**LICENSE SUA-1341  
DOCKET NO. 40-8502**

**RE: Submittal of Additional Information for December, 2000  
Decommissioning Plan, COGEMA Mining, Inc.**

**COGEMA, Mining, Inc.**  
**December 2000 Decommissioning Plan**  
**Replacement page guideline for the June 2001 revision**

### **Additional Information Concerning the December 2000 Decommissioning Plan**

Figure 3-1 Gamma Survey and Soil Sample Locations at Christensen Ranch Site

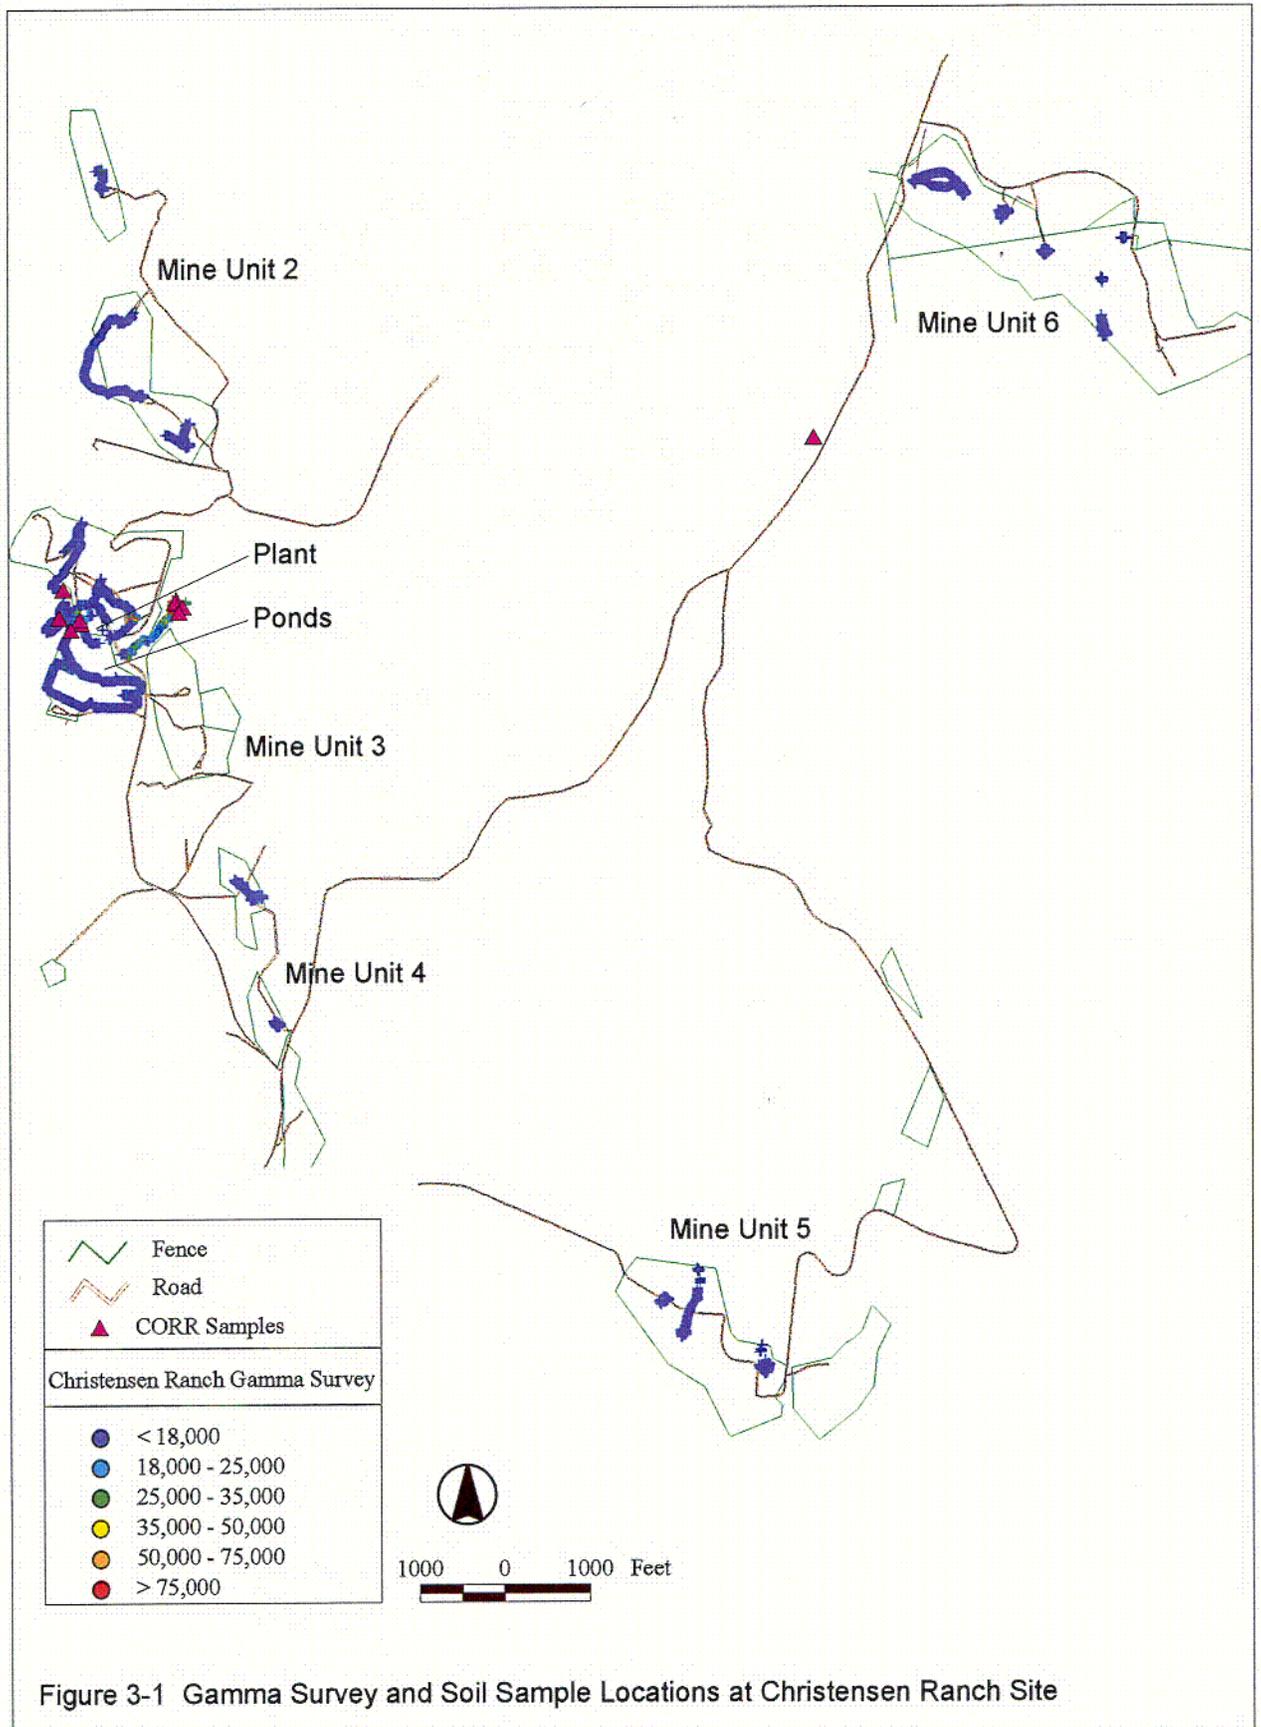
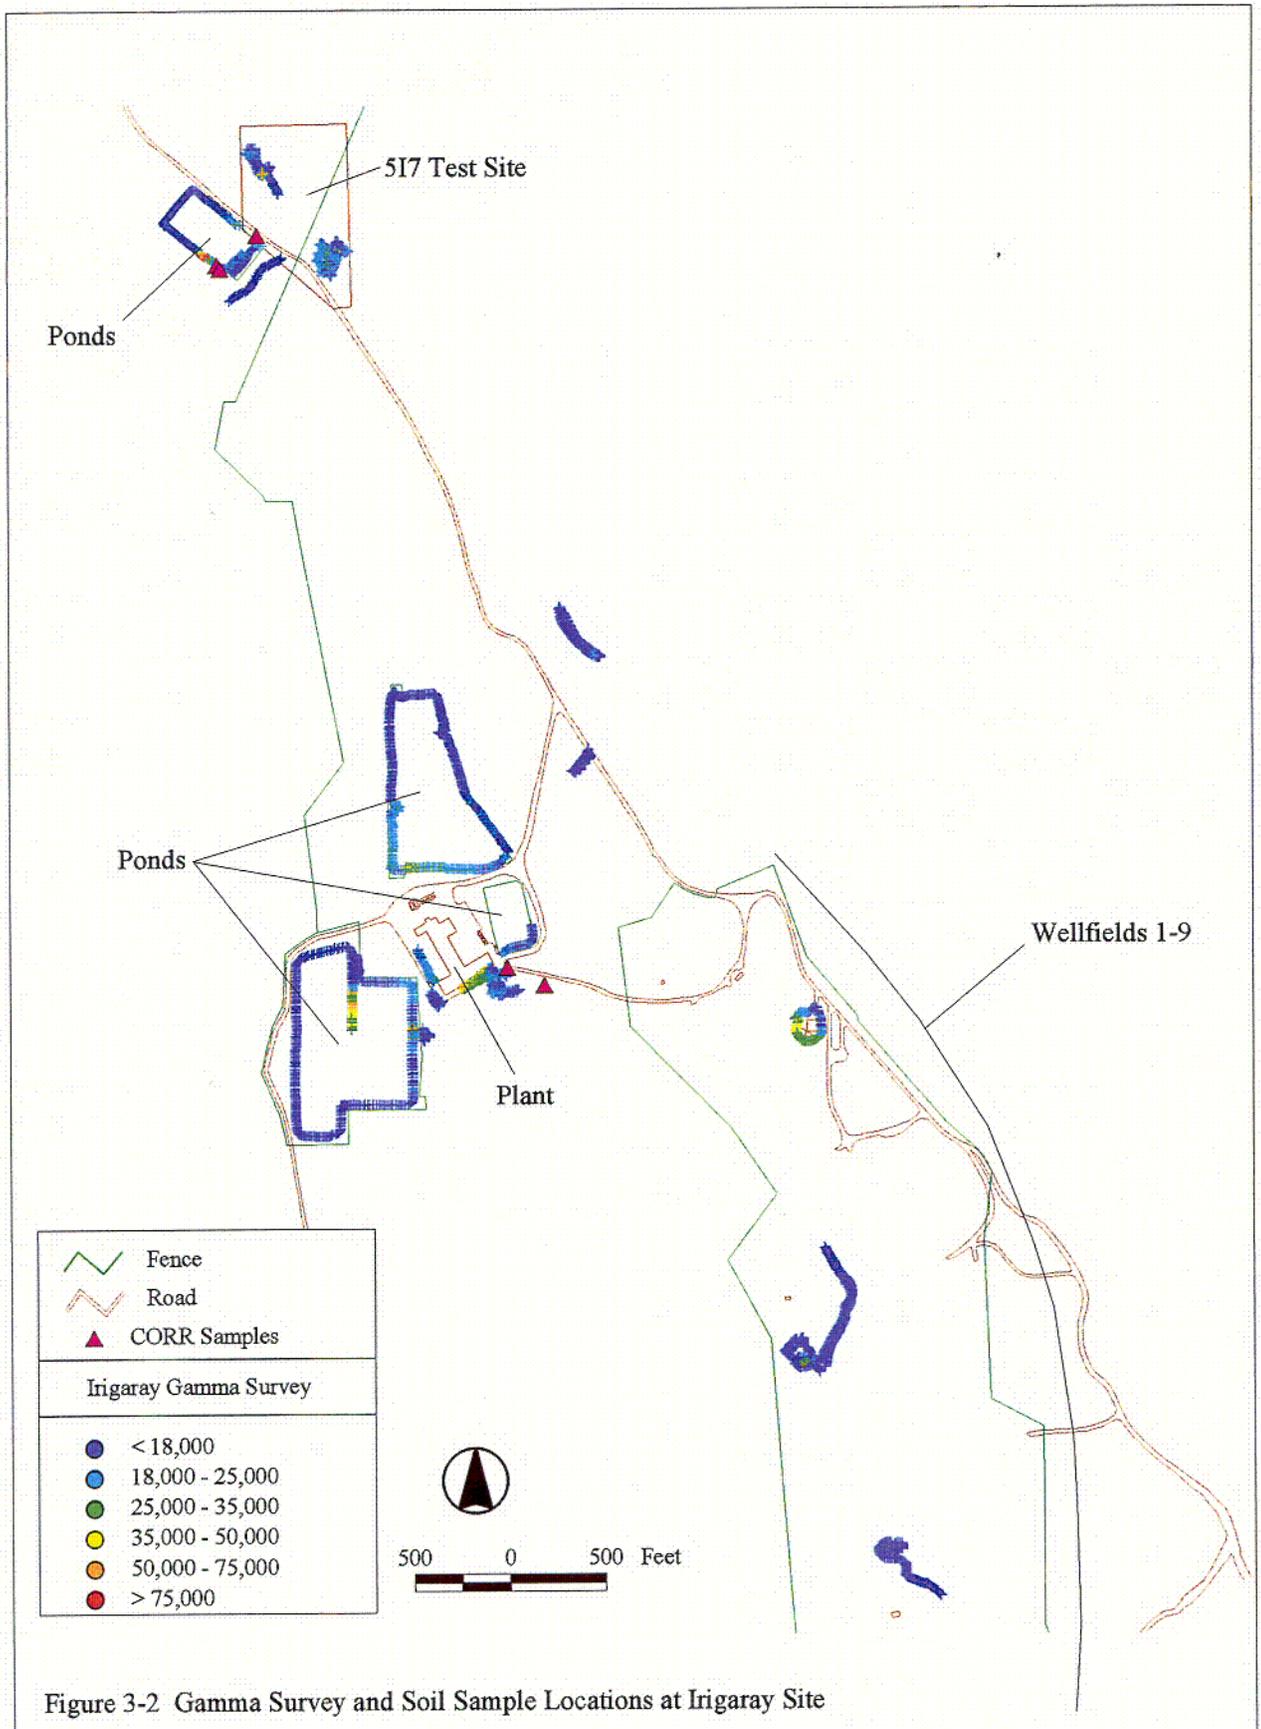
"Provide the estimated area of land (volume or size) that may require remediation. Also, clarify if the sample was obtained before the gamma reading was taken, as stated on page 36."

Section 3.2.2 (Gamma Survey and Soil Sample Data Results) was revised to indicate that the gamma readings were taken prior to obtaining soil samples.
